METROPOLITAN GOVERNMENT OF NASHVILLE AND DAVIDSON COUNTY

STAFF RECOMMENDATION
114 South 17th Street
October 15, 2014

Application: Demolition—principle; New construction—infill and outbuilding; Setback determination

Description of Project: Applicant is proposing to demolish a non-contributing single-family building at the rear of a lot and to construct new infill and a new carport in the same approximate location. The project requires a determination of the rear setback from twenty feet (20') to five feet (5').

Figure 1. 114 S. 17th St.

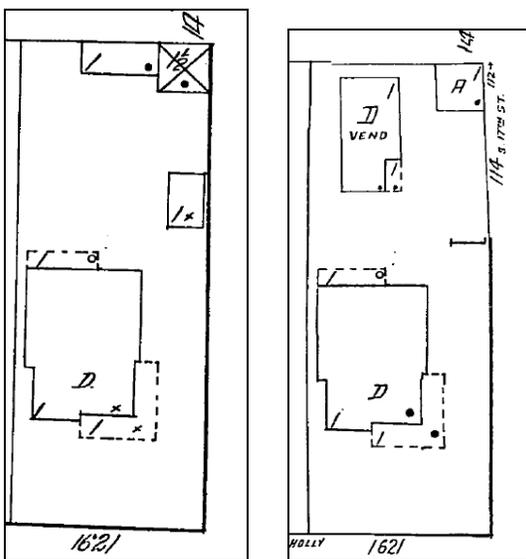
Background: 114 South 17th Street is a one-story residence constructed c. 1940 (Figures 1 & 2). The house appears on the 1951 Sanborn map, but not on the 1914 map (Figures 3 & 4). It also appears in the 1944 directory. The house is non-contributing to the Lockeland Springs-East End Neighborhood Conservation Zoning Overlay.

Demolition: Although 114 South 17th Street likely dates to the early 1940s, its style, form, and detailing do not match the historic context of the Lockeland Springs-East End Neighborhood Conservation Zoning Overlay. Its low slope roof, shallow eaves, fenestration pattern, and lack of window trim and other details are inconsistent with the predominant surrounding historic character. In addition, the building is not a good example of its period of development. Staff therefore finds that the structure does not contribute to the architectural and historical character and significance of the district, and that its demolition meets Section IV.B.2 of the *Lockeland Springs-East End Neighborhood Conservation Zoning Overlay: Handbook and Design Guidelines* for appropriate demolition.

1 Site Plan - Historic
1" = 15'-0"

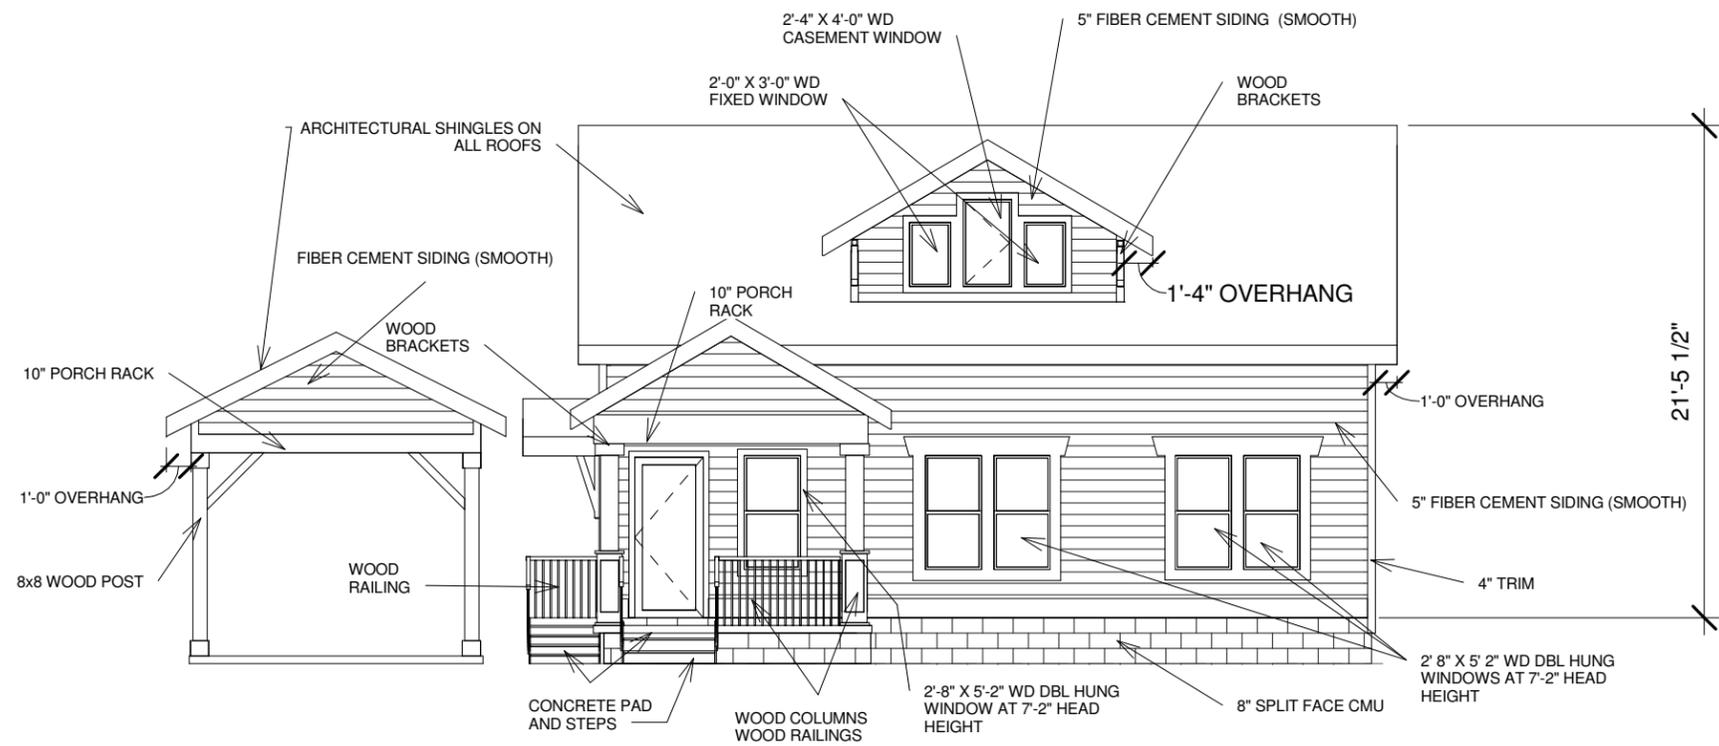
The proposed infill will be in the approximate location as the existing house that is to be demolished. It is shifted to the right/north of the lot, closer to the alley, which allows for more room in between the infill and the house at 1621 Holly Street. The infill's front wall will be approximately twenty-seven feet (27') from the South 17th Street property line. This is about six feet (6') forward of the house wall at 112 South 17th Street. The infill's partial-width front porch will extend approximately six feet (6') forward from its front wall, and will therefore be approximately seven feet (7') forward of the line of the porch at 112 S. 17th Street. Because of the shallowness of the lot and because the infill's front wall will be about four feet (4') behind the South 17th Street side wall of 1621 Holly, staff finds the front setback to be appropriate.

Even though the new infill faces South 17th Street, it is governed by the base zoning setbacks for entire site, which assumes orientation towards Holly Street. The new infill's rear façade therefore must be five feet (5') from the interior side property line. It does meet this side setback requirement. The infill's right/north side façade must be twenty feet (20') from the alley, which is the rear of the site. The infill does not meet this rear setback, as its right side façade will be five feet, one inch (5'1") from the rear/alley property line. Staff finds the proposed rear setback to be appropriate for several reasons. Shifting the infill closer to the alley allows for there to be more space between the infill and the historic house at 1621 Holly Street. In addition, the five foot (5') setback for the house's side facade is similar to typical side setbacks in Lockeland Springs, and will be in keeping with the rhythm of spacing for the other houses facing South 17th Street. Lastly, the five foot (5') setback along the alley will be similar to the alley setbacks of neighboring accessory structures, and therefore will not adversely affect visibility when driving down the alley.

Outbuildings: A one-story, one bay carport is proposed to be located to the left of the infill, in between the 1621 Holly Street structure and the new infill. The carport meets all base zoning setbacks. There will be five feet (5') in between the carport and the wall of the infill. The carport will be twelve feet, ten inches (12'10") wide and approximately eighteen feet, four inches (18'4") deep. It will have an eave height of nine feet, six inches (9'6") and a ridge height of fourteen feet, six inches (14'6"). The roof will be a gable with a slope of 6/12. The materials of the carport will be similar to those of the house, and include wood posts, architectural shingles, and fiber cement siding. An existing double-width driveway will be shifted a few feet to the left, and will be less than ten feet (10') wide. (Figure 5).

1 Historic - Front
 1/8" = 1'-0"

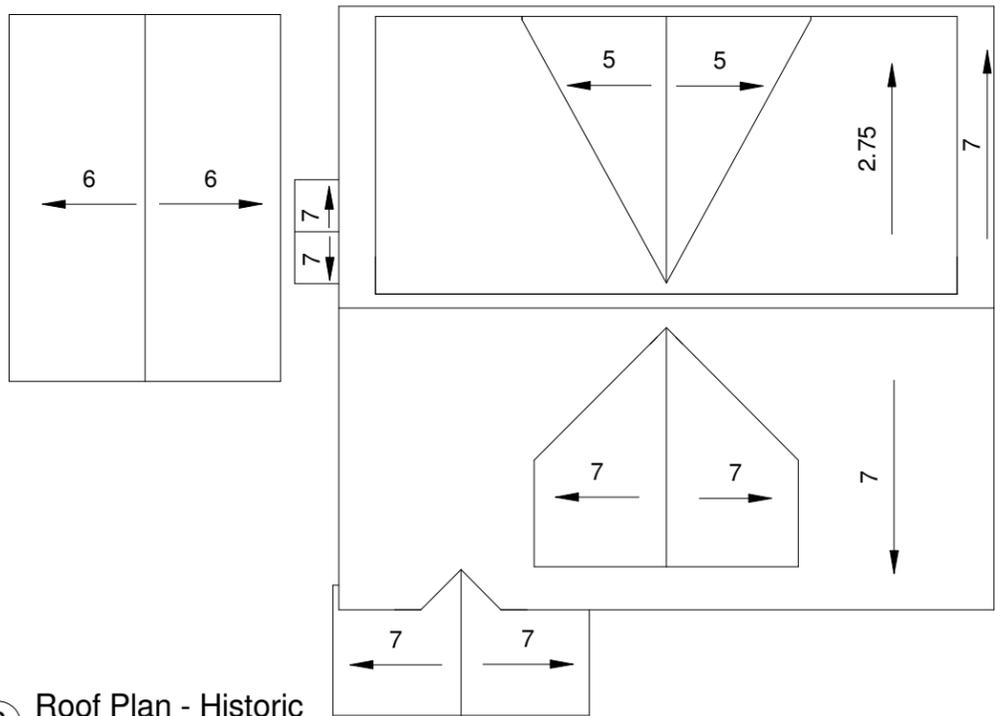
Height & Scale: The proposed infill will have a ridge height of approximately twenty-three feet, six inches (23'6") above grade. It will have an eave height of approximately thirteen feet (13') above grade, and a two foot (2') tall foundation. Staff finds that the proposed height matches the historic context. The house at 1621 Holly Street is approximately twenty-five feet (25') tall, so the new infill will be appropriately shorter than it. The other houses along 17th Street range in height from twenty-one to twenty-six feet (21'-26') tall.

Roof form: The infill will have a side gabled roof with a slope of 7/12. The front façade will have a gabled dormer that is inset two feet (2') from the wall below. The front dormer will have a 7/12 pitch. The rear façade has a shed dormer that is inset two feet (2') from each of the side walls. The rear dormer has a primary slope of 2.75/12 with a central gable feature with a slope of 5/12. Staff finds that the proposed roof form matches the historic context and meets section II.B.5. of the *Lockeland Springs-East End Neighborhood Conservation Zoning Overlay: Handbook and Design Guidelines*

Orientation: The house is oriented to face 17th Street, which is appropriate. The proposed house has a partial-width front porch that is six feet (6') deep. Staff asks that a walkway be added from South 17th Street to the house's porch. Staff finds that the proposed infill meets section II.B.6. of the *Lockeland Springs-East End Neighborhood Conservation Zoning Overlay: Handbook and Design Guidelines*

1 Historic - Rear
1/4" = 1'-0"

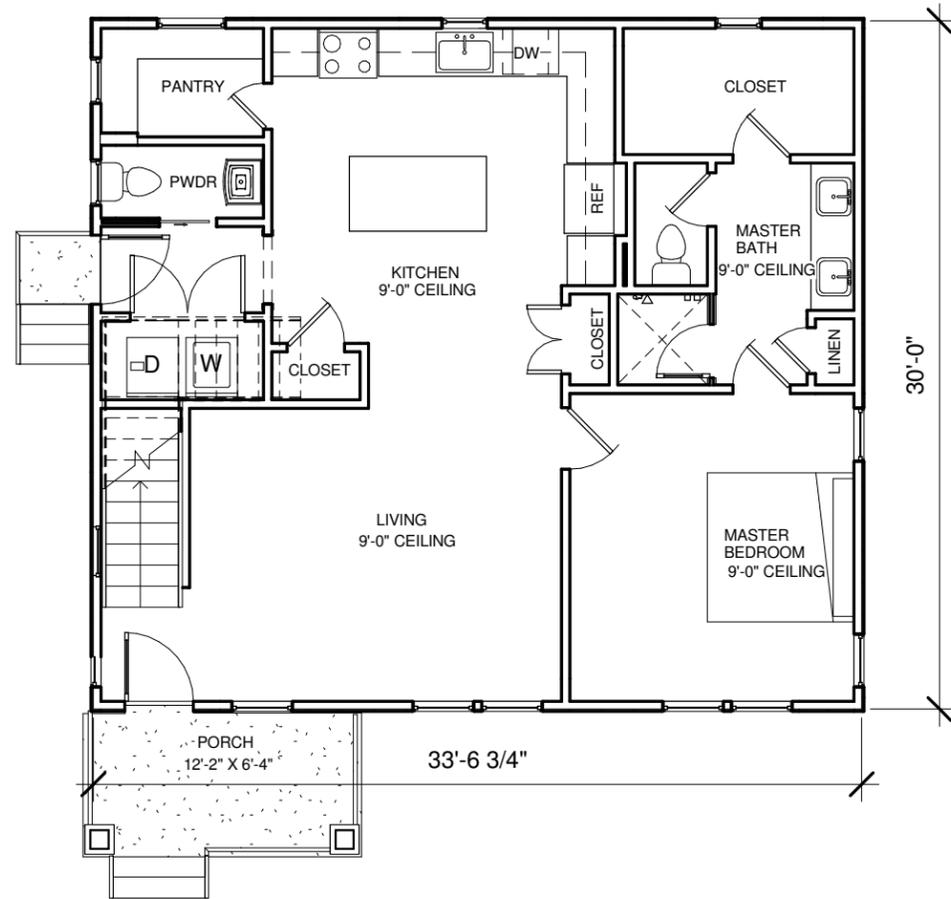
Proportion and Rhythm of Openings: The primary windows on the infill are all generally twice as tall as they are wide, thereby meeting the historic proportions of openings. There are no large expanses of wall space without a window or door opening. The rear façade does contain a horizontal, transom-like window, but staff finds this window to be acceptable on this façade because it will not be visible from a public street. Staff finds the project's proportion and rhythm of openings to meet Section II.B.7. of the *Lockeland Springs-East End Neighborhood Conservation Zoning Overlay: Handbook and Design Guidelines*
